Access Compliance Report

Public Rights-of-Way

Intersection ID: 52289	Main Street: TROJAN_DR	Cross Street: DIXIE_RIVER_RD	Location:	N
ADA ID: 0A05330E8DA3	Ramp Type: Perp	Initial Pass/Fail: Fail	Overall Compliance: No	Severity Score: 12.5

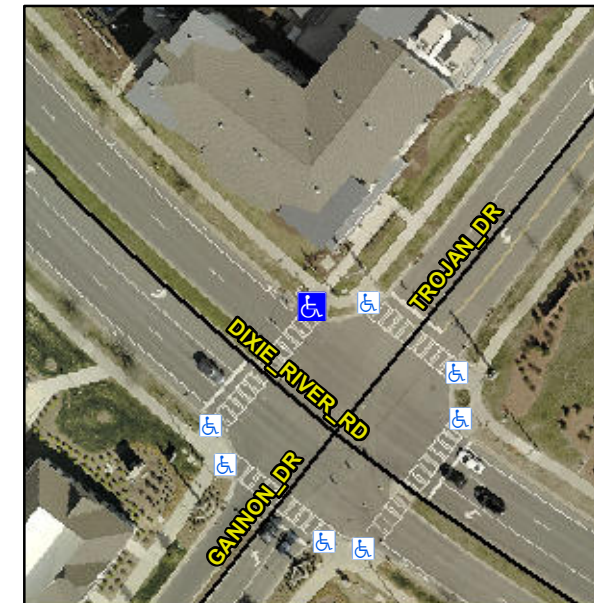
Not Found, R304.5.3

Compliance	Description	Data	Compliance	Description	Data
N/A	Ramp Length (in)	84.0	Yes	Ramp Slope (%)	6.4
Yes	Ramp Width (in)	48.0	No	Ramp XSlope (%)	6.7
N/A	Flare Type LT	N/A	N/A	Flare Type RT	N/A
N/A	Flare Slope LT (%)	N/A	N/A	Flare Slope RT (%)	N/A
N/A	Flare Traversable LT?	N/A	N/A	Flare Traversable RT?	N/A
N/A	Landing Length (in)	N/A	N/A	DWS Provided?	N/A
N/A	Landing Width (in)	N/A	N/A	DWS Contrast?	N/A
N/A	Landing Slope (%)	N/A	N/A	DWS Length (in)	N/A
N/A	Landing X Slope (%)	N/A	N/A	DWS Full Width?	N/A
N/A	Landing Curb? (Y/N)	N/A	N/A	DWS Offset (in)	N/A
N/A	Shared Landing?	N/A			
N/A	Gutter Ponding?	N/A	N/A	Gutter Slope (%)	N/A
N/A	Gutter Lip Ht (in)	N/A	N/A	Gutter X Slope (%)	N/A
N/A	Painted X Walk1?	Yes	N/A	Painted X Walk2?	N/A
	X Walk 1 Direction	To SW		X Walk 2 Direction	N/A
N/A	X Walk 1 Width (in)	114.0	N/A	X Walk 2 Width (in)	N/A
	X Walk 1 Slope (%)	1.6		X Walk 2 Slope (%)	N/A
	X Walk 1 X Slope (%)	4.0		X Walk 2 X Slope (%)	N/A

Remove & Replace Entire Ramp.
